Inspection Report

Permit Number:	C0150019
Inspection Type:	PARTIAL
Inspection Date:	Tuesday, March 20, 2018
Start Date/Time:	3/20/2018 10:00:00 AM
End Date/Time:	3/20/2018 2:00:00 PM
Last Inspection:	Wednesday, February 7, 2018

Permitee: **PACIFICORP**
 Operator: **INTERWEST MINING CO**
 Site: **COTTONWOOD/ WILBERG**
 Address: **PO BOX 310, HUNTINGTON UT 84528**
 County: **EMERY**
 Permit Type: **PERMANENT COAL PROGRAM**
 Permit Status: **ACTIVE**

ATTACHMENT A – Cottonwood Inspection March 20, 2018

PHOTO 7

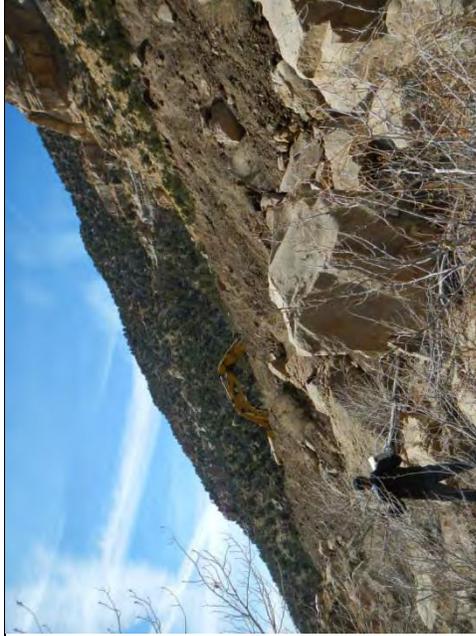
Noted an area with little to no hydromulch at the outcrop, West side subdrainage Left Fork

Put more boulders on this reclaimed slope above undisturbed Grimes Wash
